REVISION #1 - 3/17/2025: FBEG

REVISION #2 - 6/4/2025: EKG

MIDPOINT MEADOWS
PHASE 1

CITY PROJECT NO. 15331
CONTRACT NO. 9538

TYPICAL SECTION
S HIGH POINT ROAD
(NORTH OF STARNOVA DR)

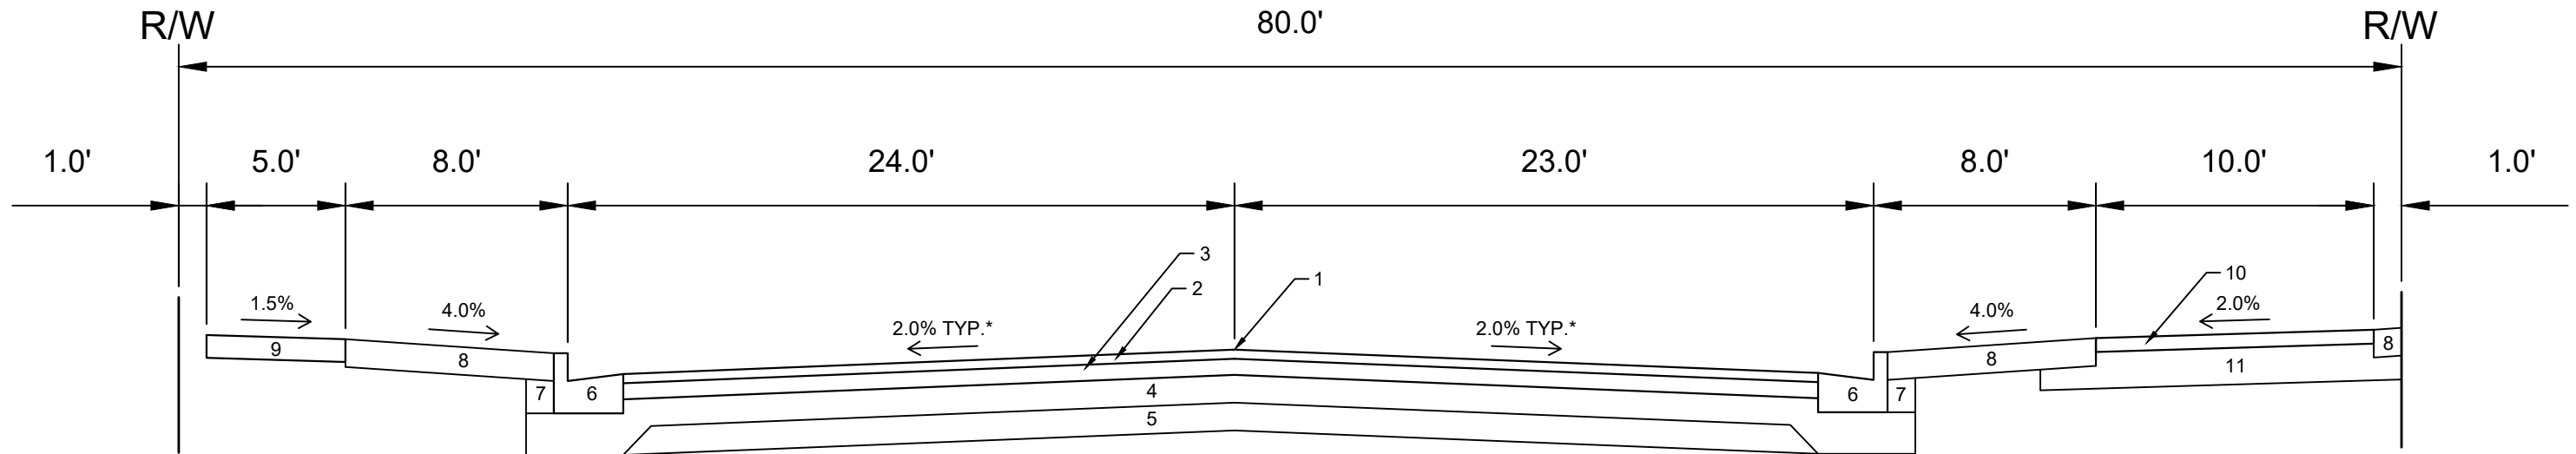
REVISION #1 - 3/ 11/ 2025: FBEG
1. CHANGED NOTE FOR PAVEMENT TYPE ON SOUTH HIGH POINT ROAD FROM TYPE 'B' TO TYPE 'C'

ALL PAVEMENT IN THE SOUTH HIGH POINT ROAD, AND MID-TOWN ROAD (FUTURE) RIGHT-OF-WAY SHALL BE TYPE C PAVEMENT PER STANDARD DETAIL DRAWING 4.02.

TYPICAL SECTION
PUBLIC EASEMENT ALONG
LOTS 250 - 237

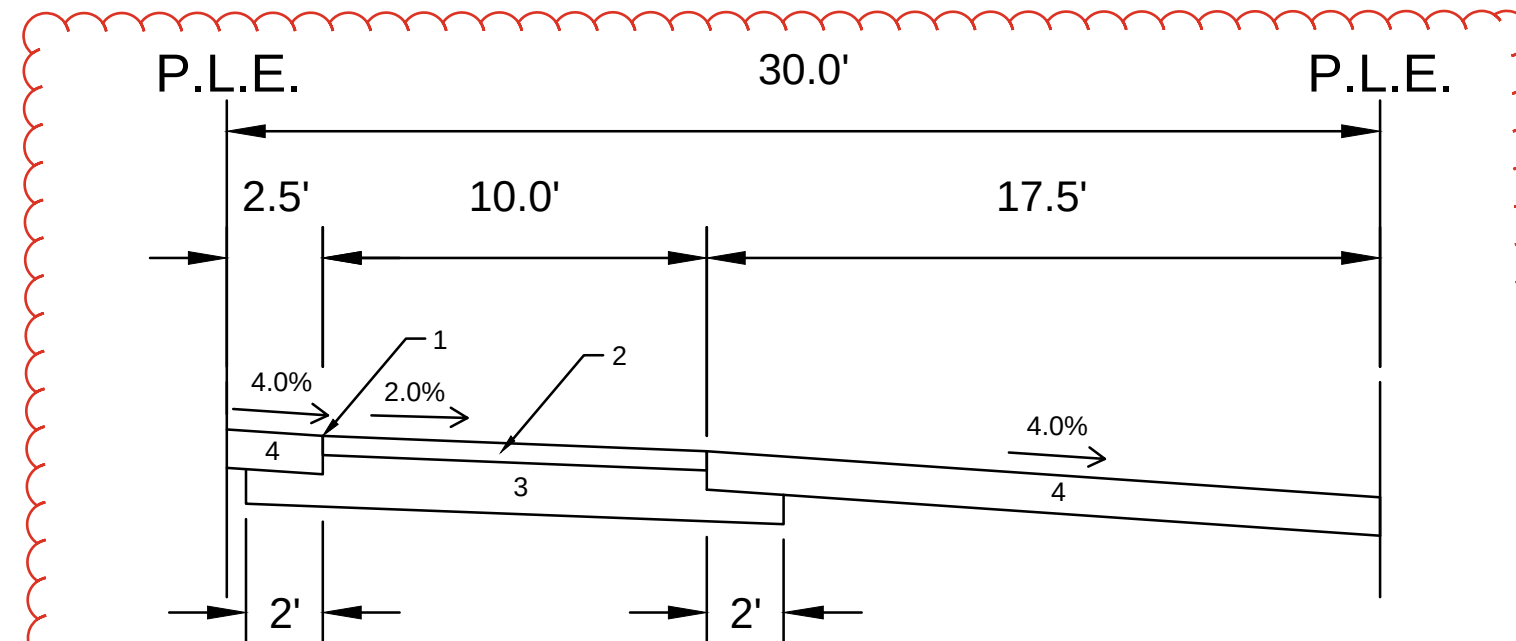
REVISION #1 - 3/ 11/ 2025: FBEG

1. PLAN REVISED TO CHANGE 5' WIDE CONCRETE SIDEWALK TO A 10' WIDE ASPHALT PATH, REPLACED GRAVEL PATH WITH 6" TOPSOIL, SEED, & MAT. MERGED 2 EASEMENTS INTO 1 30' WIDE.

15331		MADISON, WI		CONTRACT NO: 9538	
PLAN & PROFILE - SHARED USE PATH ALONG LOT 218		MIDPOINT MEADOWS - PHASE 1		M:\DESIGN\Projects\15331\CAD\Streets\15331\EN-PnP.dwg	
		15331		P-13	
MARK	REVISION	DATE	BY	Scale: 1" = 40'	
15331	15331	3/11/2025 5:59 PM	FBEG	P-13

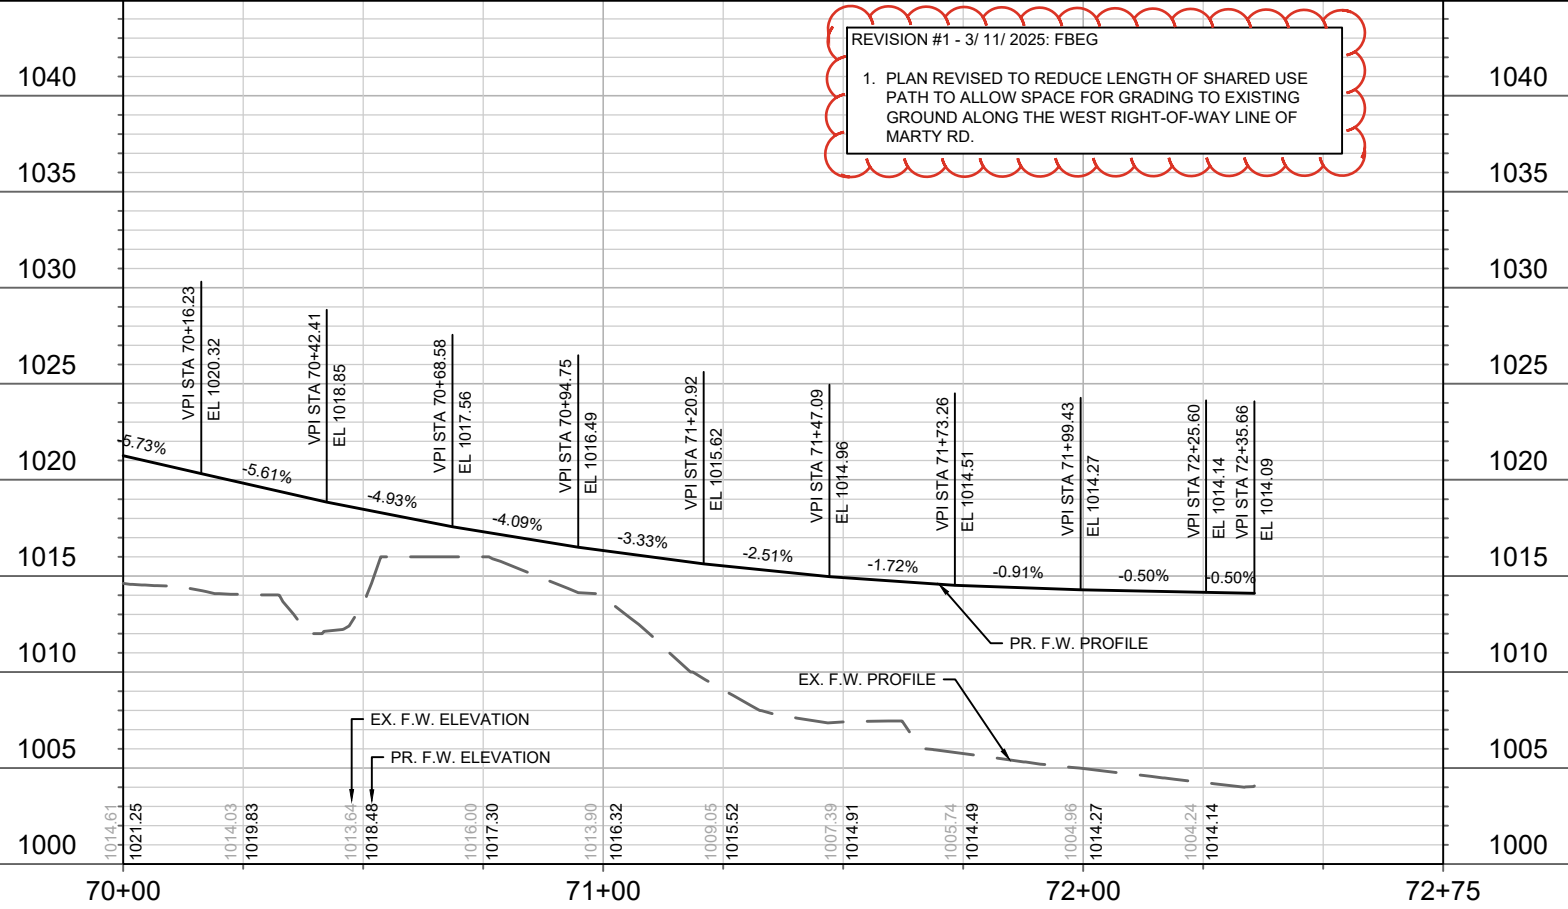
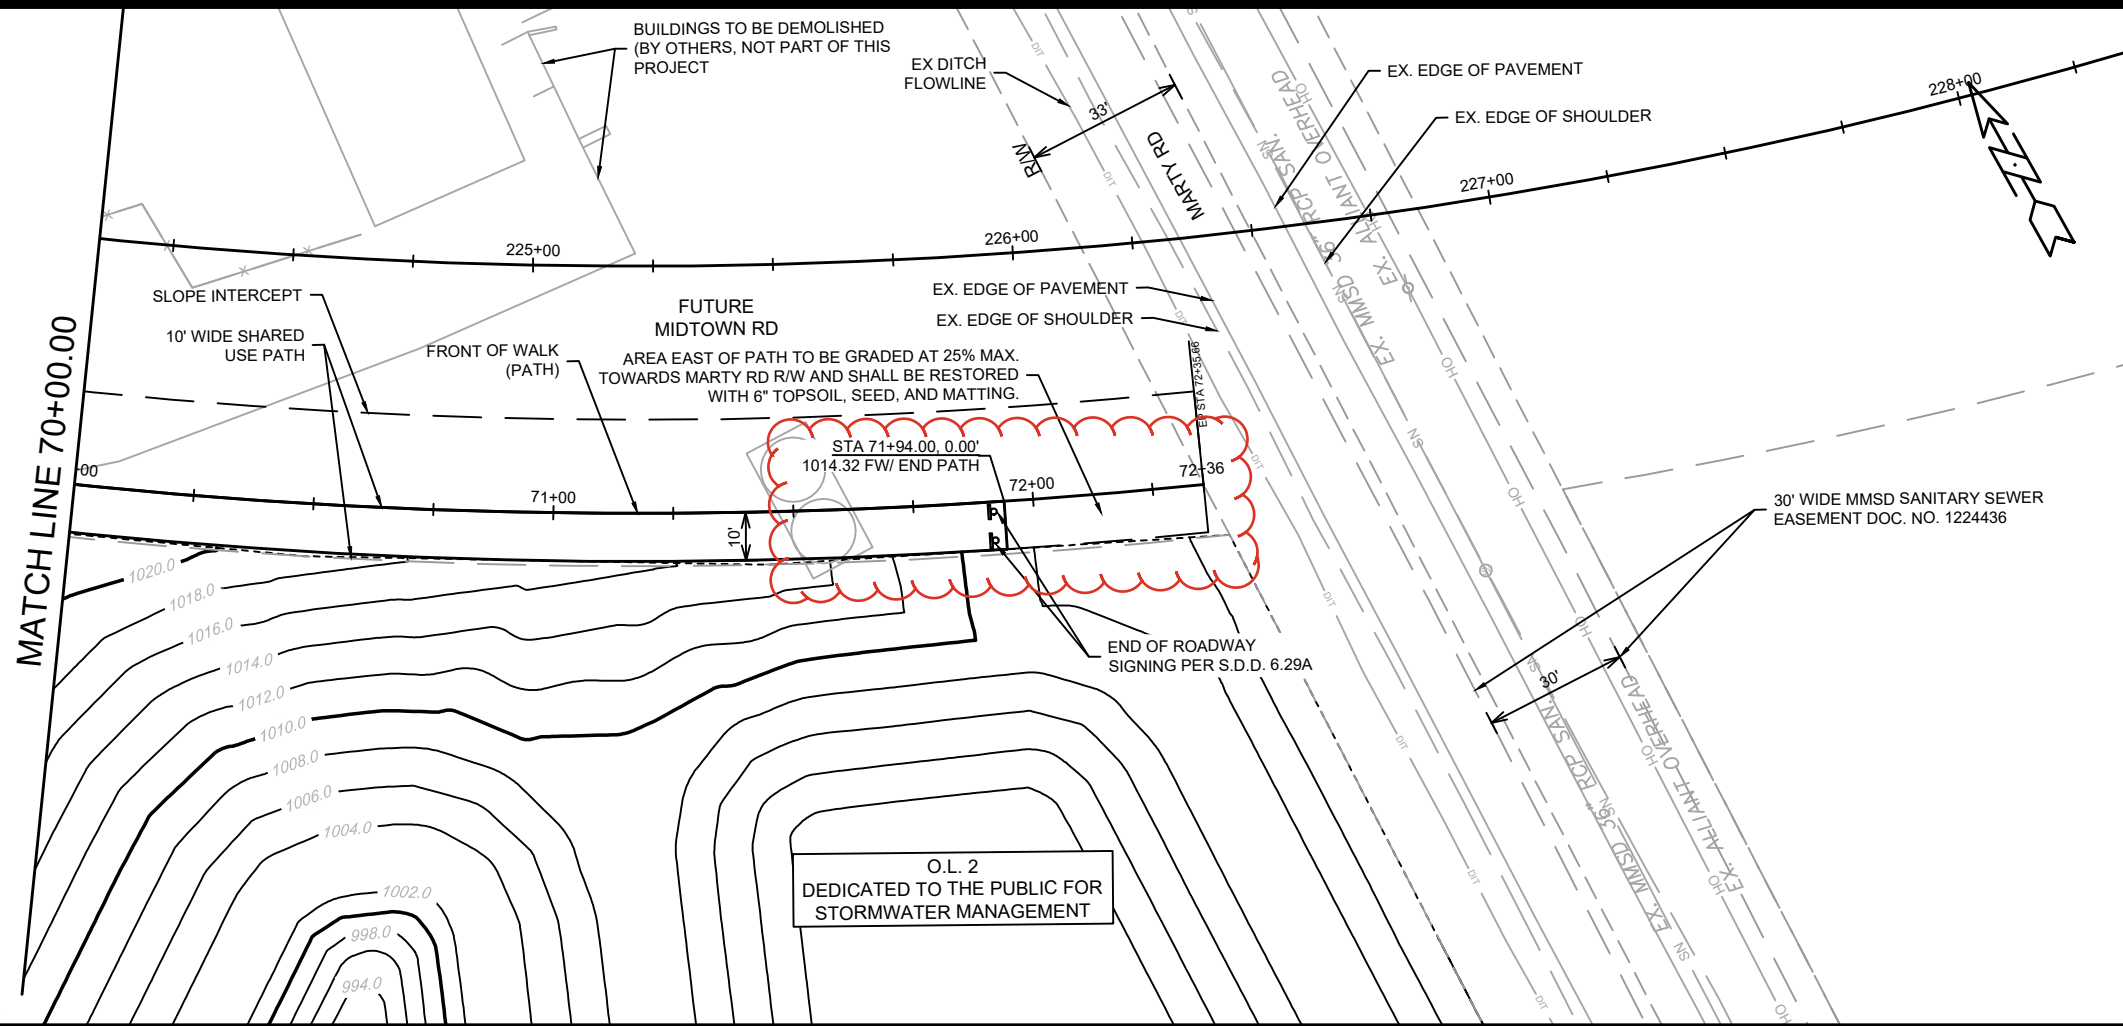
REVISION #1 - 3/11/2025: FBEG

1. PLAN REVISED TO REDUCE LENGTH OF SHARED USE PATH TO ALLOW SPACE FOR GRADING TO EXISTING GROUND ALONG THE WEST RIGHT-OF-WAY LINE OF MARTY RD.

15331		MADISON, WI		CONTRACT NO: 9538	
UTILITIES PLAN & PROFILE - FIELD DAISY WAY		MIDPOINT MEADOWS PHASE 1		U-5	
M:\DESIGN\Projects\15331\CAD\Sewers\15331SWR-PipeNetwork.dwg		15331		U-5	
DATE: 3/13/2025 9:12 AM		REVISION		BY	
Scale: 1" = 40'

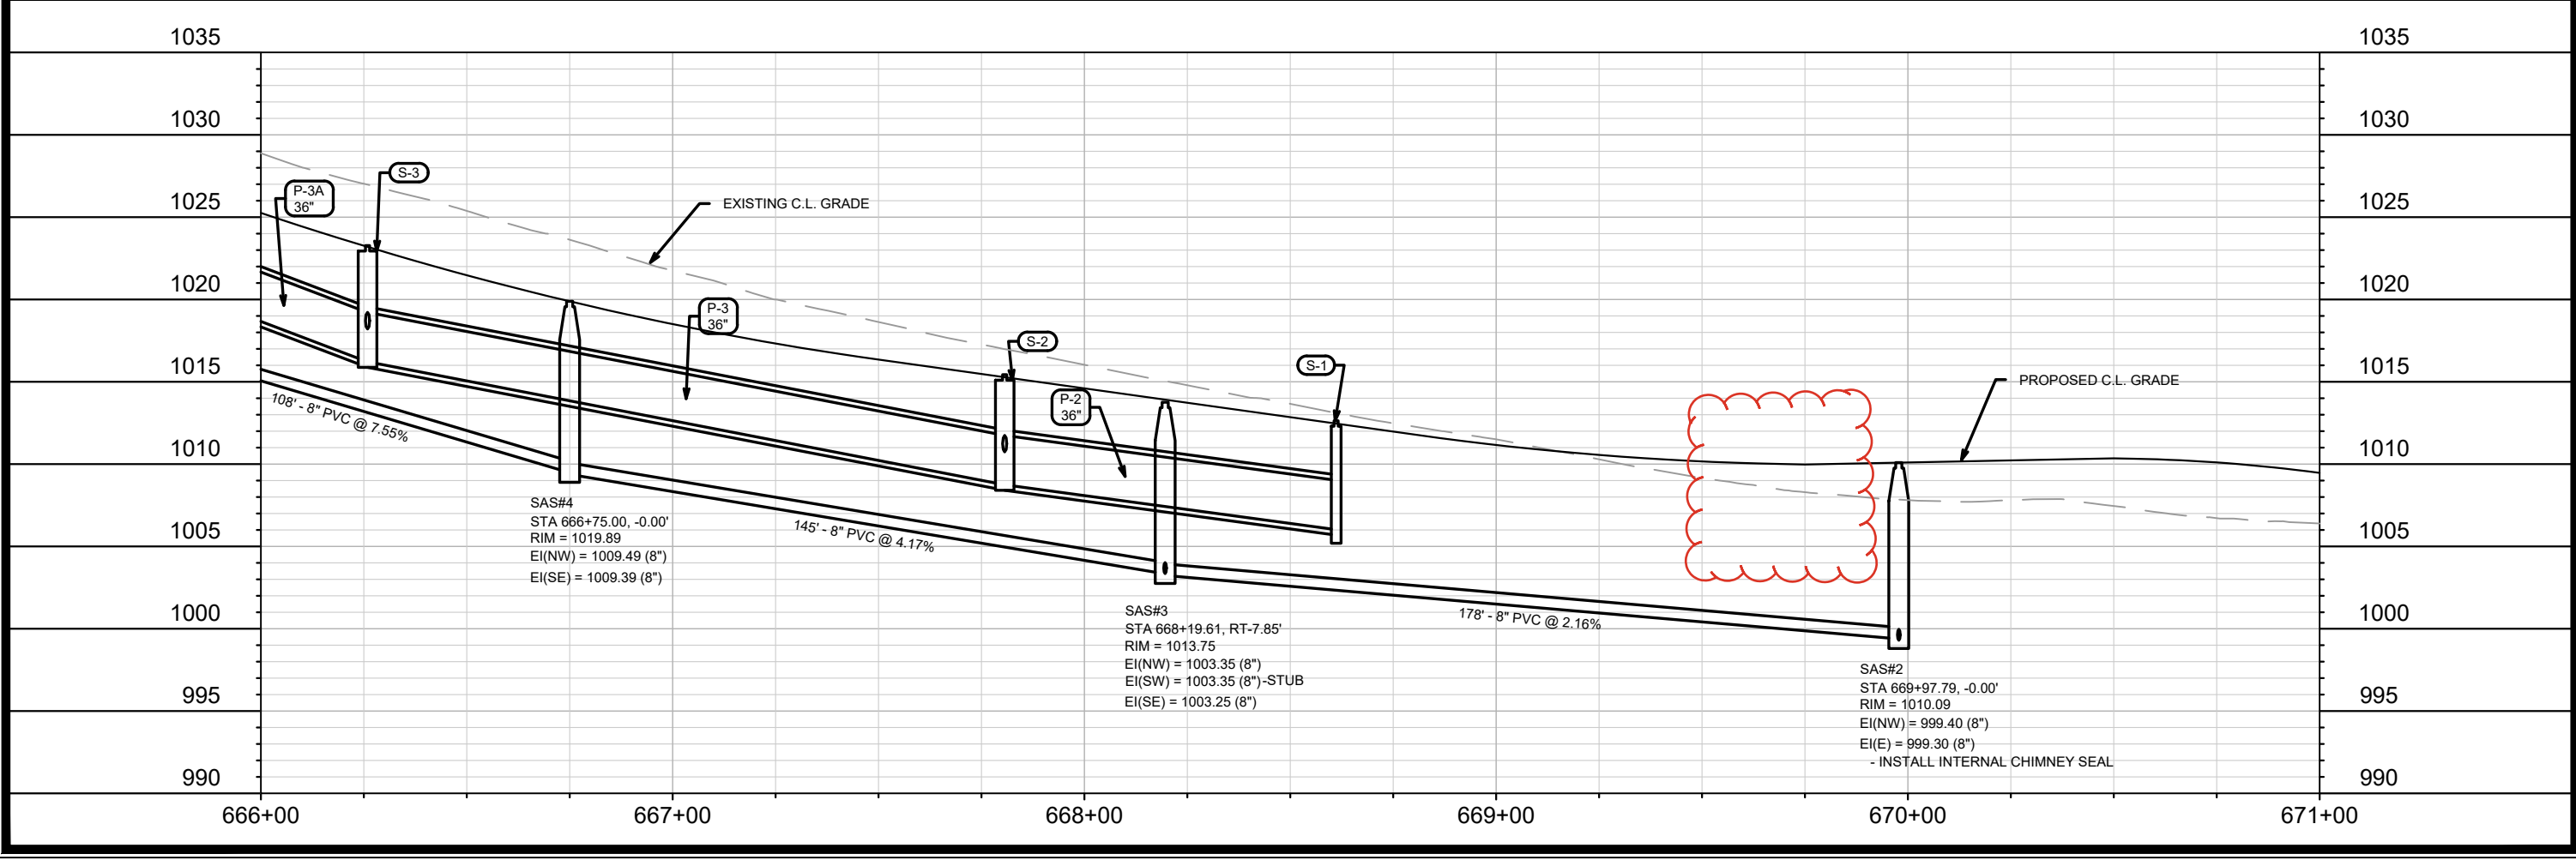
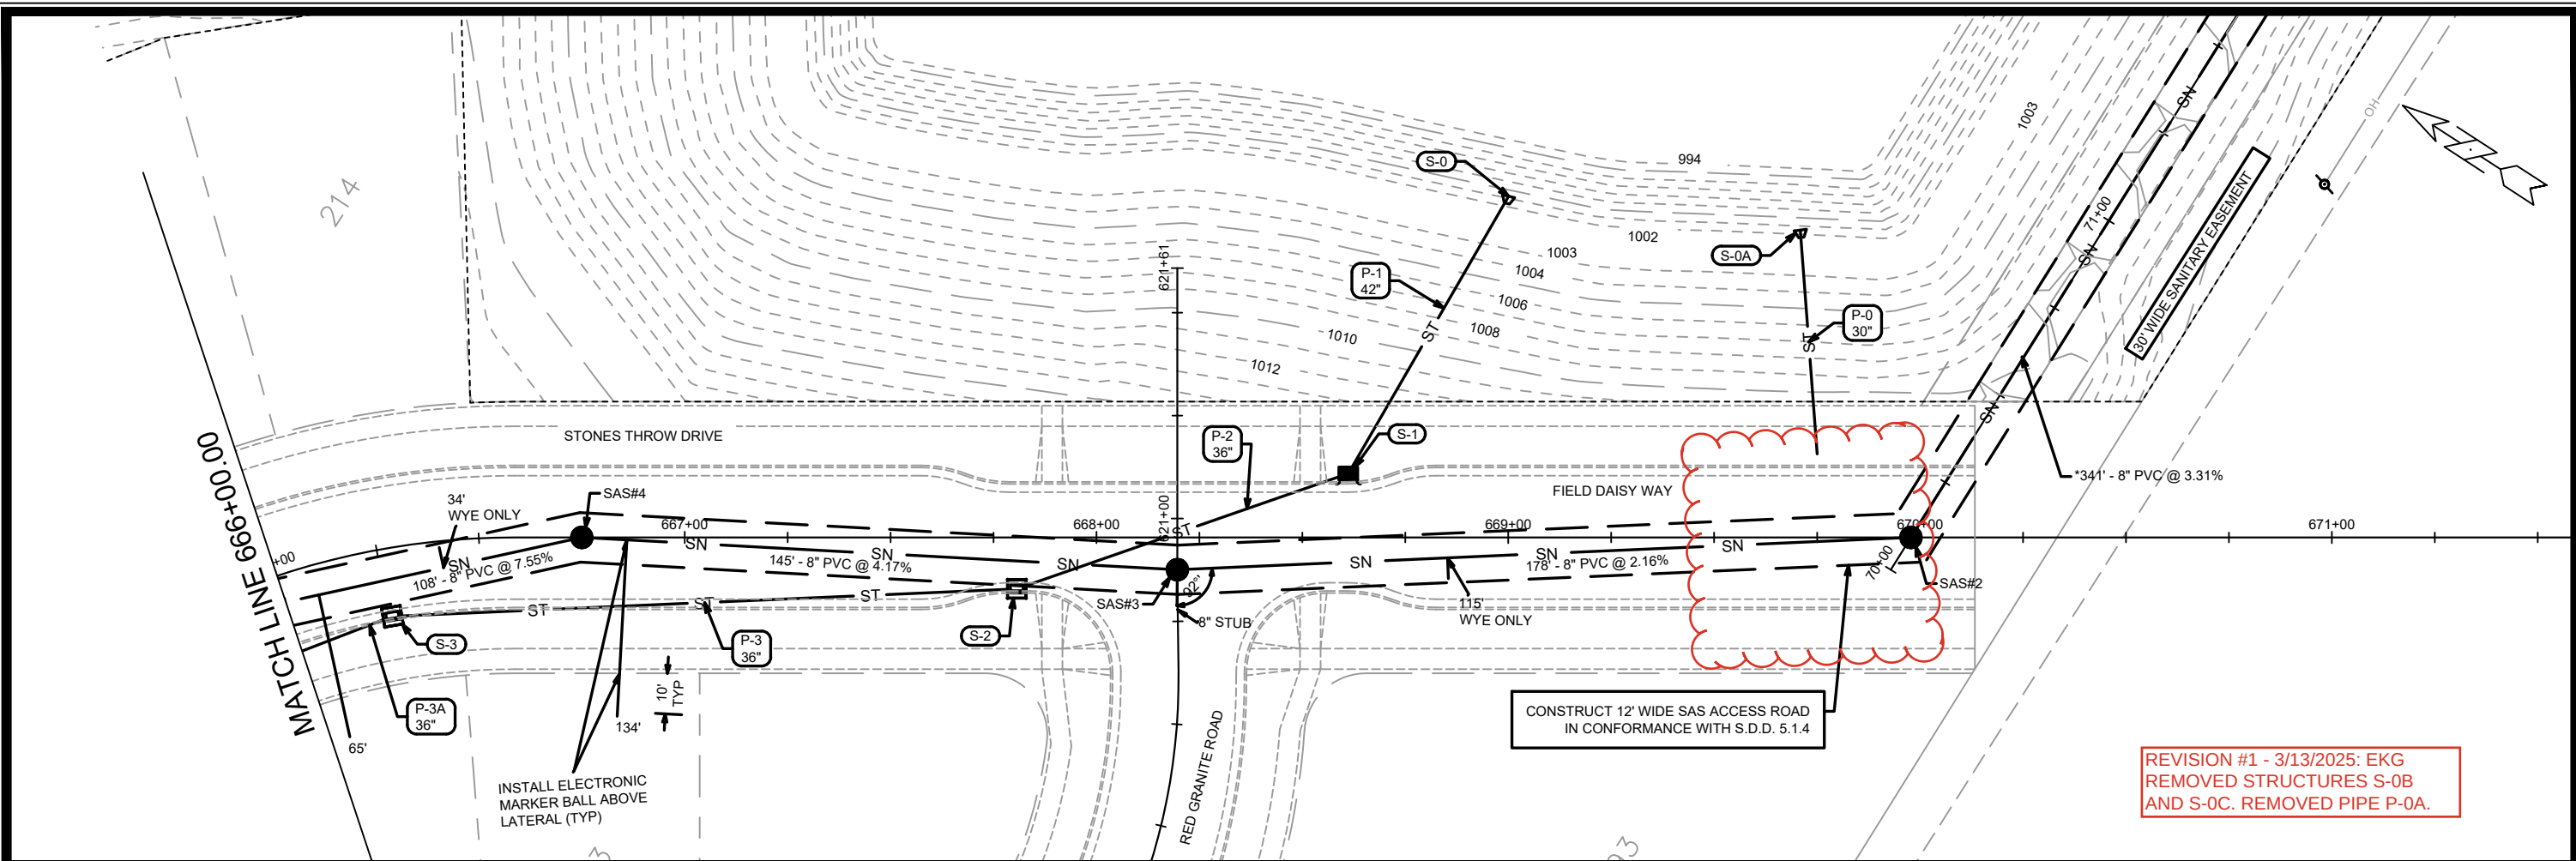
REVISION #1 - 3/13/2025: EKG
REMOVED STRUCTURES S-0B
AND S-0C. REMOVED PIPE P-0A.
